Service Bulletin

Bulletin No: JC-13-26

Product Type: Specific Predator Pro, ProCat G & H series machines manufactured between August 2011 and February 2012.

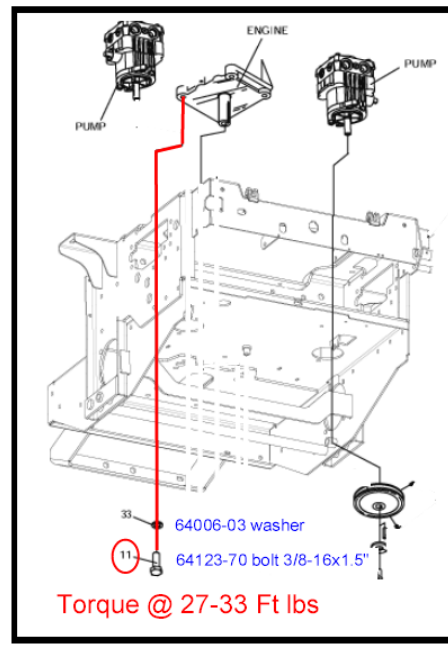
Customer Issue: Engine shaking/moving or making a racket. This is especially noticeable upon starting the engine or engaging the clutch.

Cause: The engine bolt torque may not have been consistently applied to the engine mounting bolts. We have found that some units manufactured during this period may have engine mounting bolts which could work loose. If this is the case, it will typically become an issue before the first 100 hours of use. Note: The customer is responsible to maintain all hardware as outlined in the Owner's Manual. However, under this circumstance, we will honor warranty for this adjustment the first 100 hours or first year, whichever comes first.

Action Required: Re-torque all 4 engine bolts to 27-33 Ft Lbs. (If any hardware is missing or damaged, replace it.)
